# UNITED STATES PATENT AND TRADEMARK OFFICE

10/575,052

<b>Office Action Summary</b>	<b>Application No.</b> 10/575,052	<b>Applicant(s)</b> LAMBERT ET AL.	
	<b>Examiner</b> JUSTIN JONAITIS	<b>Art Unit</b> 3752

## **DETAILED ACTION**

**Exhibits A and B presented by Applicant in Office Action response Filed 05/26/2009**

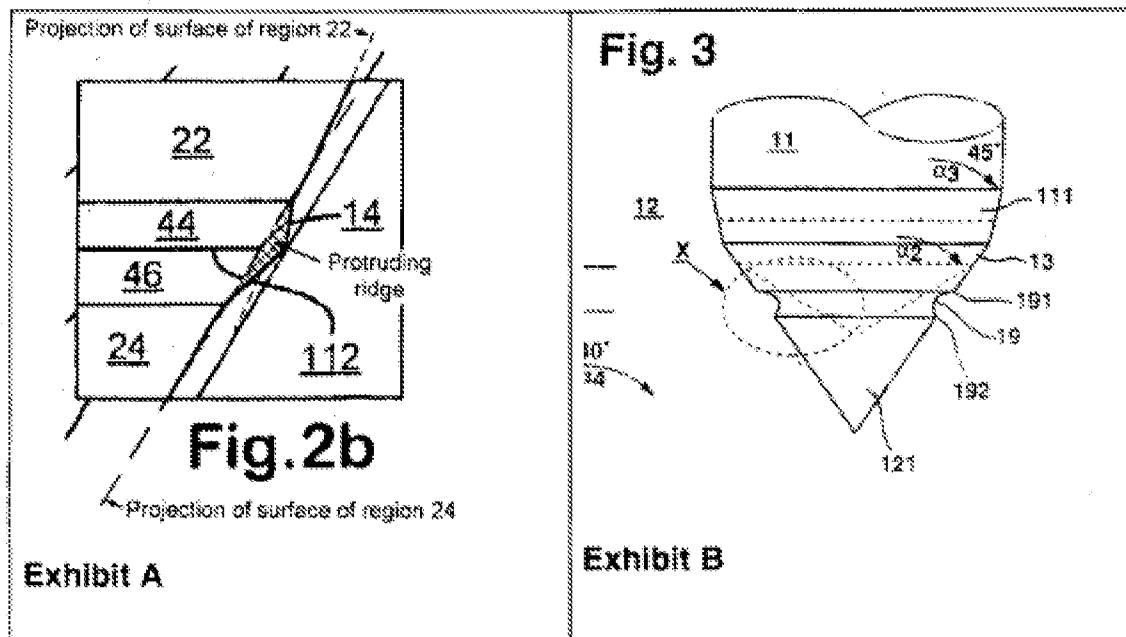
In regard to claims 1-4, applicant submits Exhibits A and B (see above), and states that the Danckert et al. reference's seating line is defined by the intersection of two regions and not the additional raised ridge disclosed in the applicant's Figure.

Examiner would like to point out that the seating line of the applicant's figure is provided by the intersection of two regions, which are Upstream Ridge Region (44) and Downstream Ridge Region (46) in the same manner that Danckert's lower half of the transition surface (111) and the top half of the sealing surface (13) form a seating line.

Examiner would also like to present Exhibit B in a more appropriately scaled form to compare to applicant's Exhibit A in order to clarify why the Danckert reference is not deficient in defining the protruding ridge.

**Exhibit B provided by Applicant appropriately Resized**

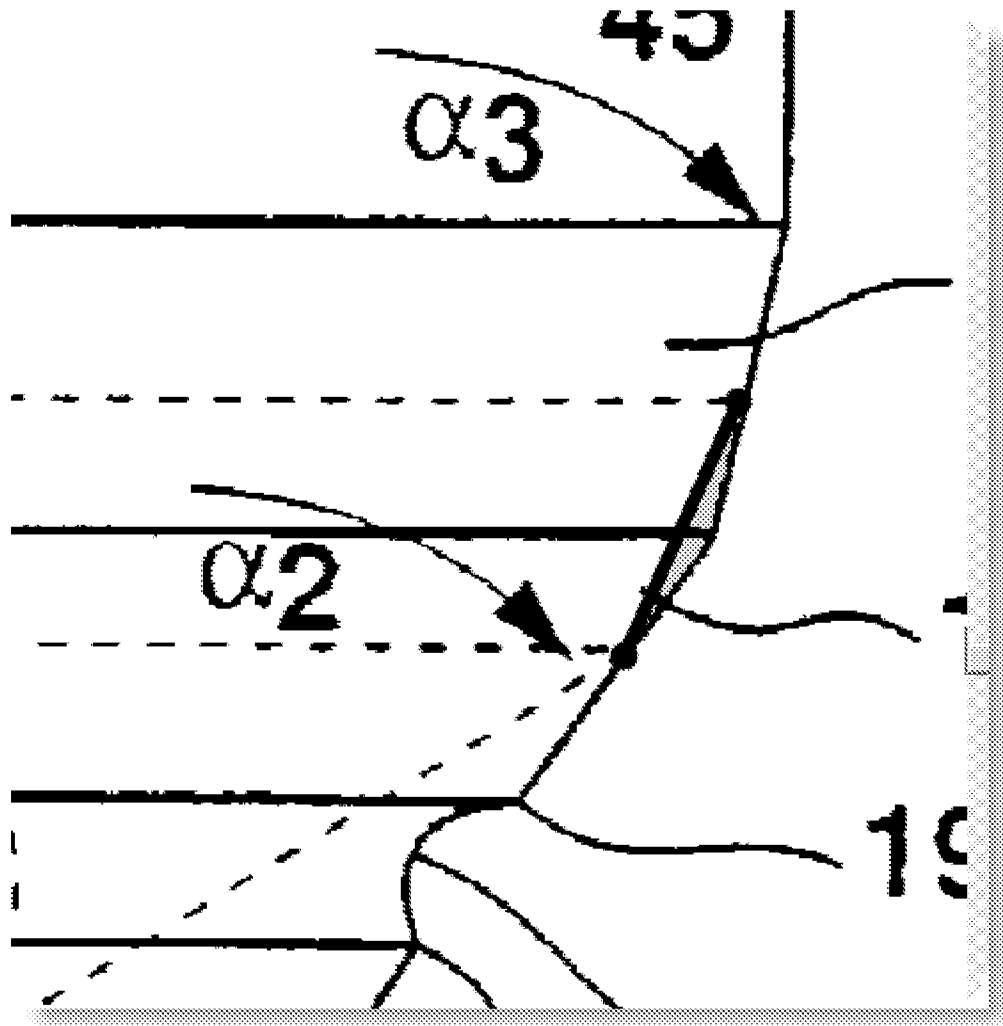
In the zoomed view of Exhibit B, a line was added to connect the outer wall of the mid section of the transition surface (111) and the seating surface (13), and the protruding portion was greyed out to more clearly define itself. Clearly it can be seen that the surfaces of Danckert disclose a protruding ridge provided by the lower half of transition surface (111) and the top half of seating surface (13) in the same manner as applicant's protruding ridge is defined by the upstream ridge region (44) and the downstream ridge region (46)
